TREE COMMENTS:**Application No: 23/1202 Former Army museum****DATE: 03/03/24****Terminology:**

03/03/24 Document ref: PJC.1280.006 Rev B dated 28th Feb**03/03/24 Document ref: PJC.1280.005 Rev - D**

Drawing no: PJC.1280.003

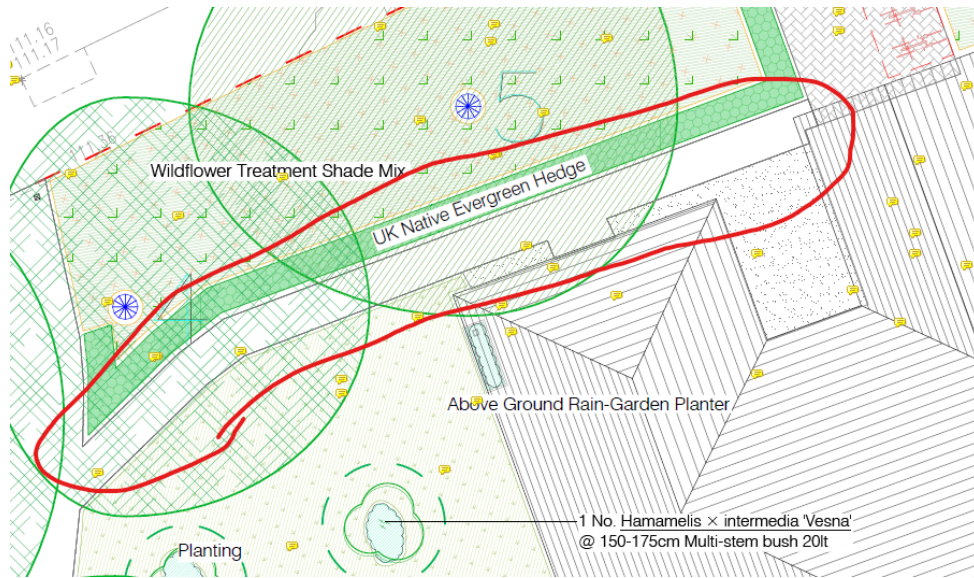
These details are accepted.**Soft landscape specification PJC 1280.005 Rev c**
